TRAIL & SIDEWALK FEASIBILITY STUDY – PHASE 1

Madeline Avenue, From County Road 483 (Clyde
Morris Boulevard) to State Road 5A (Nova Road) &
Bruner Road, From Stillwood Court to Madeline
Avenue

City of Port Orange

FINAL Report, January 2019

CONCEPT PLANS PHASE 1	
SHEET NO. 6

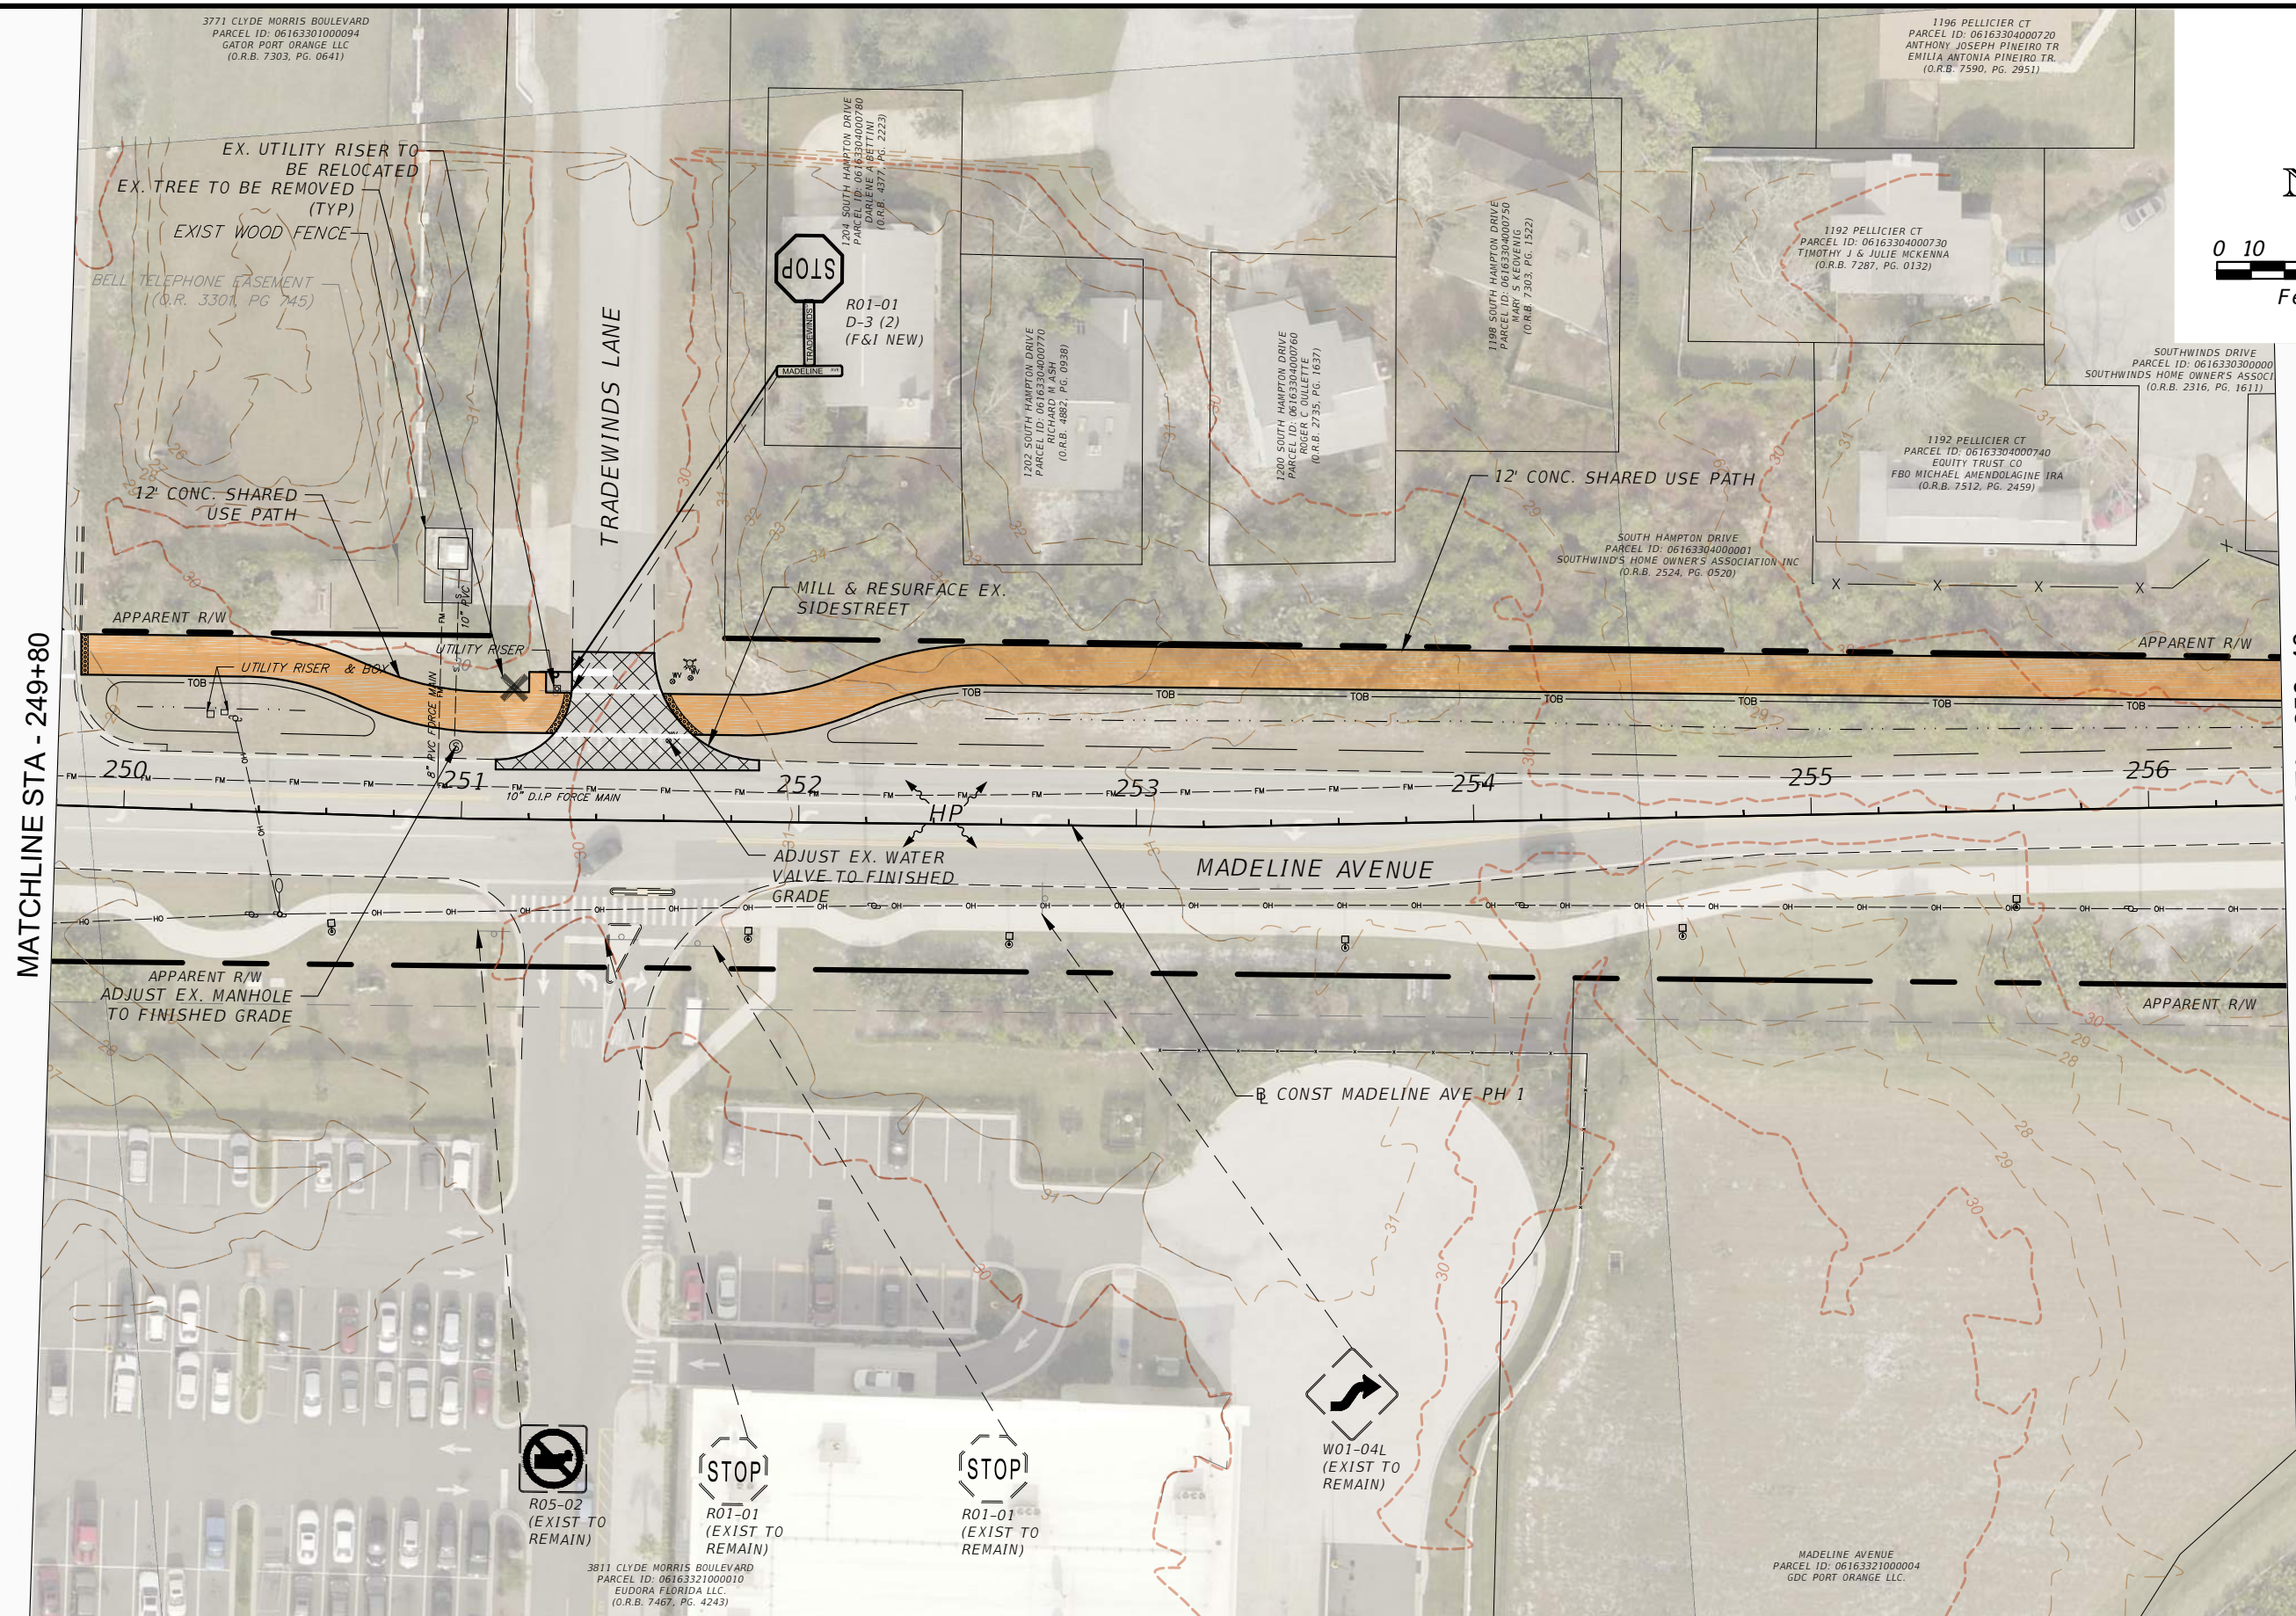
3. Sheet 6,7, and 8: Can the type of replacement fence (Southwinds Subdivision) not be specified to give flexibility on the type during design. Would the section of fence in Phase 1 of Southwinds Subdivision also need to be removed and replaced as it appears to be located in or along the right-of-way? At the meeting staff had with the Southwinds Subdivision design of the fence was discussed and staff indicated that type would be addressed at design stage.

4. The Feasibility Study application was for a minimum 8' sidewalk/multi-purpose trail along the north side of Madeline Avenue and the draft Feasibility Study calls for sidewalk/multi-purpose trail width between 8' to 12' (Sheet 5, 6, and 7). City request it is indicated in the Feasibility Study that the sidewalk/multi-purpose trail along the north side of Madeline Avenue be a minimum of 8' wide to give flexibility on the width during design. City may opt to build an 8' wide sidewalk/multi-purpose trail to reduce construction and future maintenance cost.

CONCEPT PLANS PHASE 1	
SHEET NO.	
16

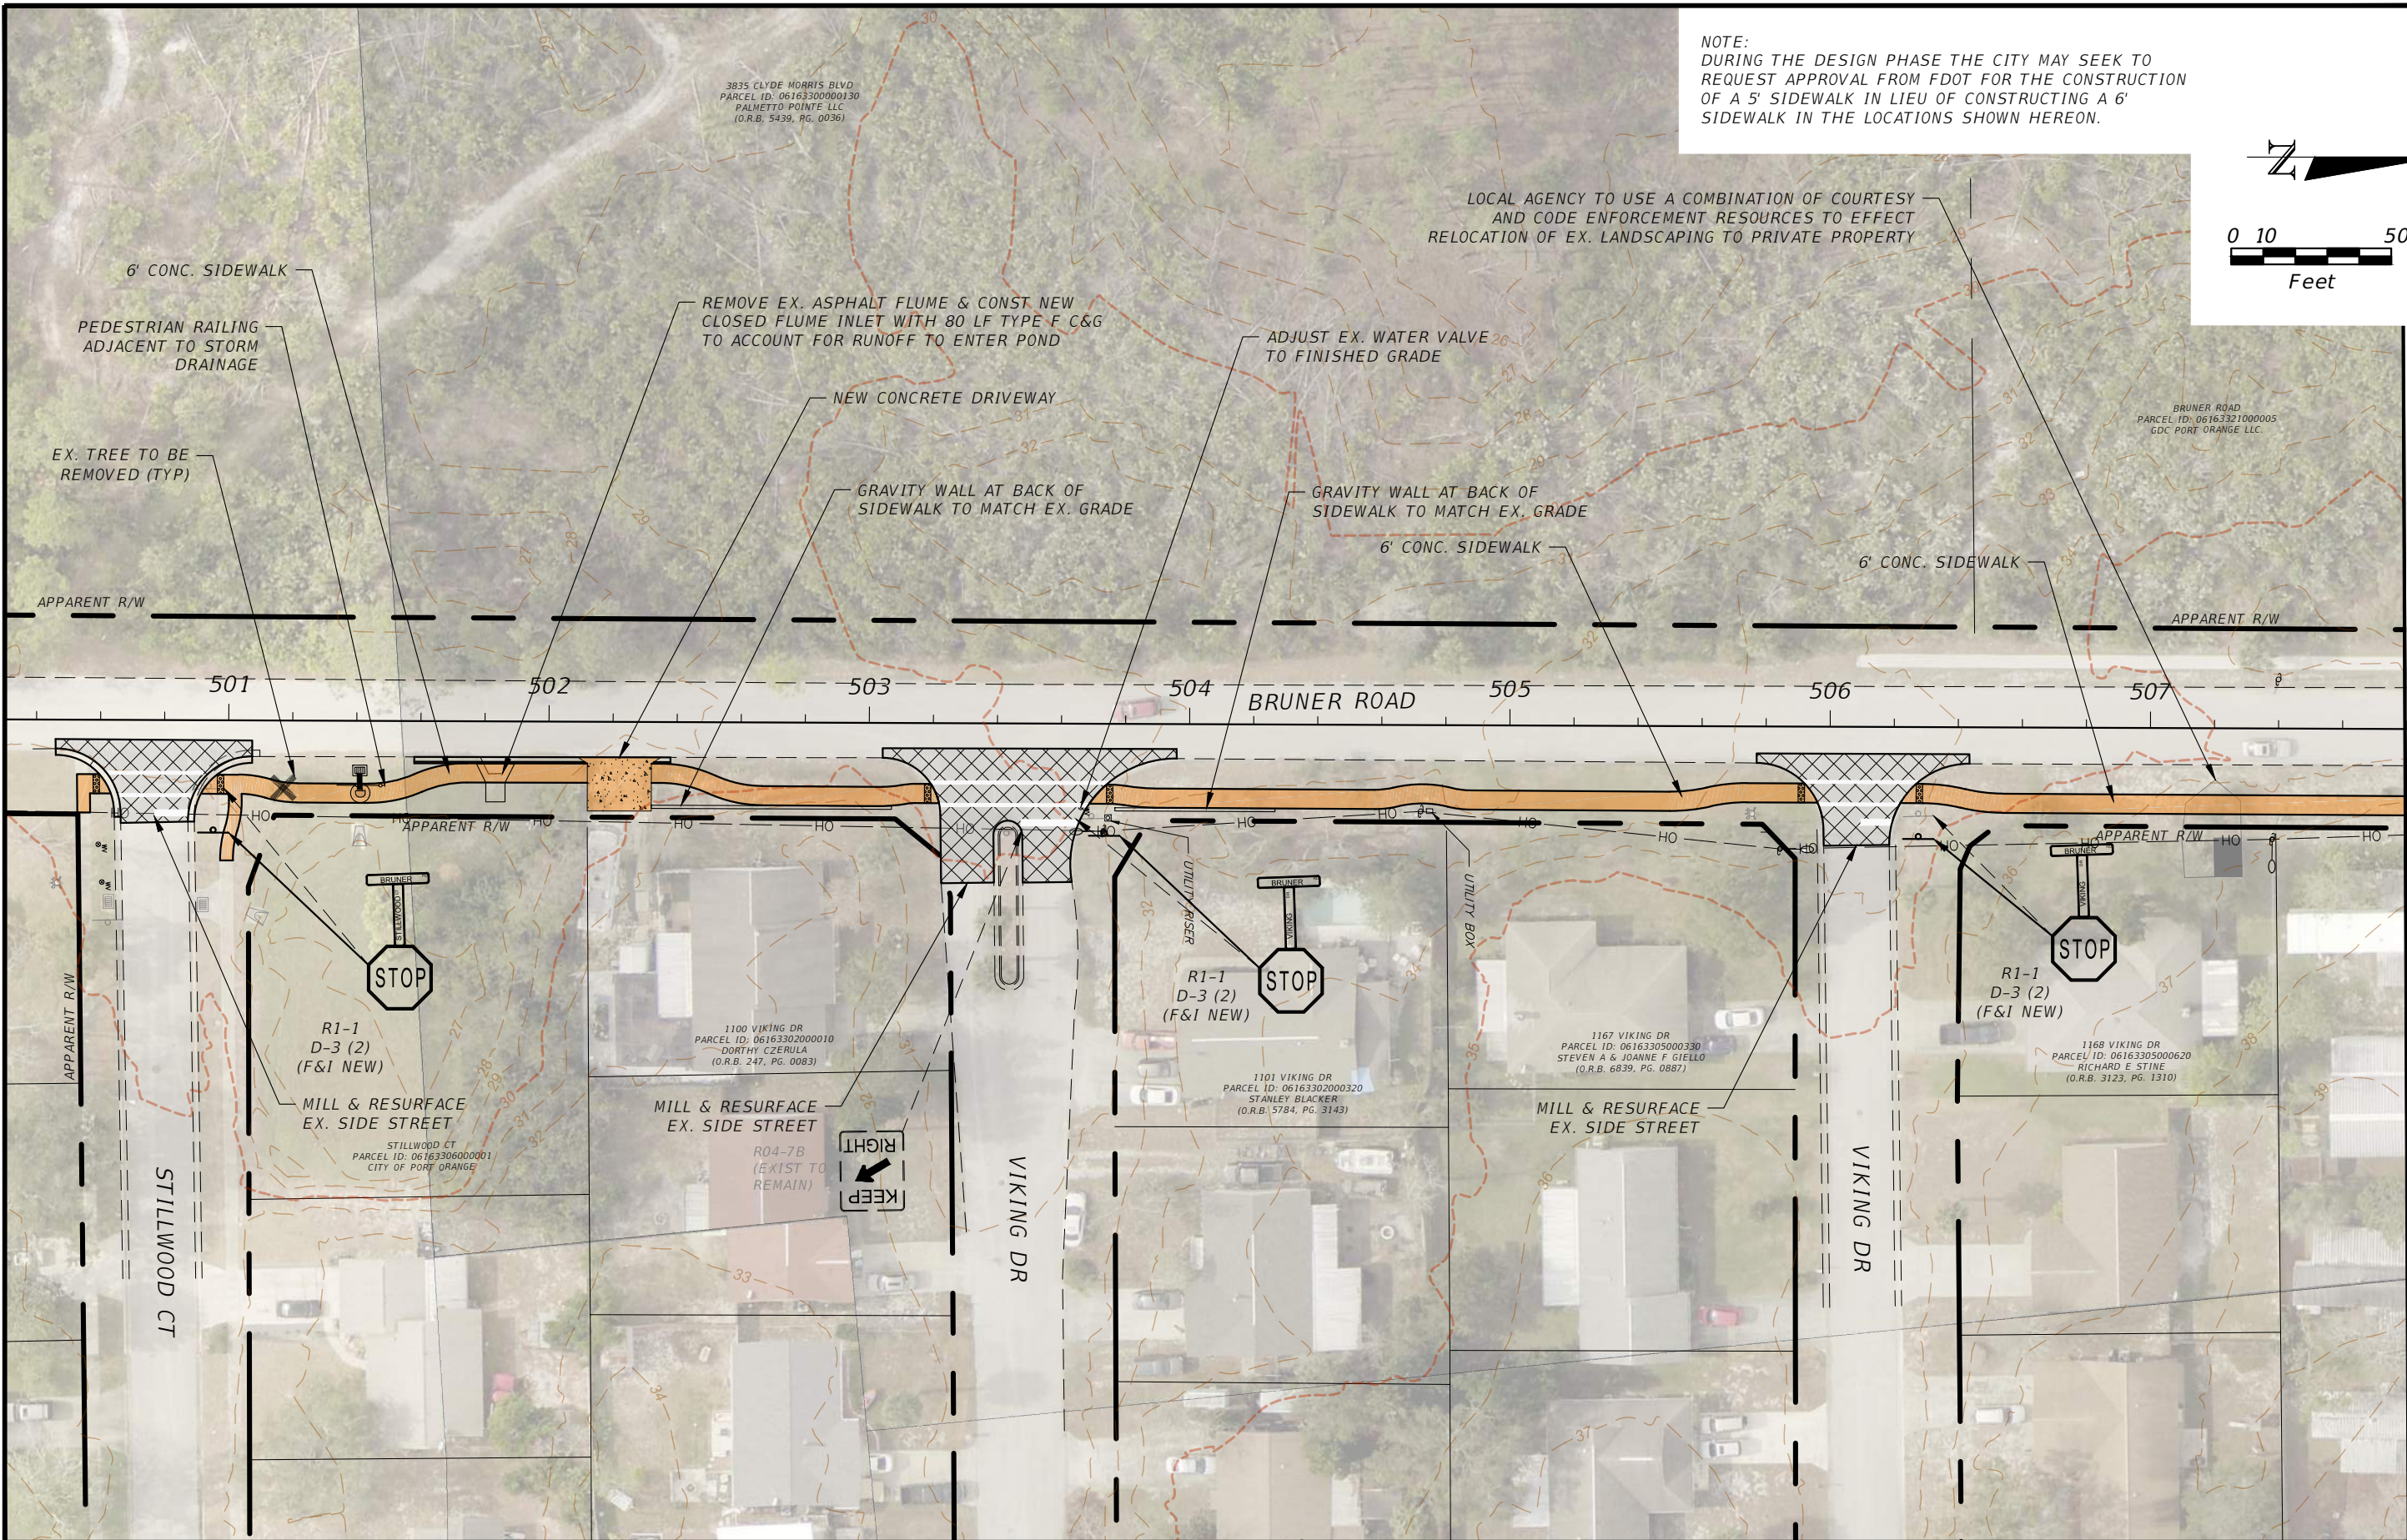
2. The original Feasibility Study application was for a minimum 5' sidewalk along the east side of Brunner Road and the draft Feasibility Study calls for a 6' sidewalk (Sheet 4, 7 and 16). City request it is indicated in the Feasibility Study that the sidewalk along the east side of Brunner Road be designed as 6' wide with alternate bid quantities for a 5-foot sidewalk with a one-foot wide earthen berm between top of swale and 5-foot sidewalk to accommodate a 6-foot sidewalk. City may opt to build a 5' wide sidewalk to reduce construction and future maintenance cost.

15. On Sheet 16 on Bruner Road at station 501+90, revise the sidewalk route where it doesn't appear to have 5 feet of separation from the path of travel.

16. On Sheet 16, revise callout at shed in right-of-way at station 507+10 to indicate Local Agency to use a combination of courtesy and code enforcement resources to effect for shed at to be moved back on private property.

5. Sheet 16 Concepts – 6" conc. Sta. 502+20 RT: This would need to be reviewed for eligibility with FHWA, with consideration given to its reason for exposure to vehicles.

Response: Sheet 16 has been revised to indicate Local Agency to use a combination of courtesy and code enforcement resources to effect relocation of the landscape timbers, but based on the aerial photo and site visits, the existing shed sits on private property, approximately 5' east of the overhead pole line.
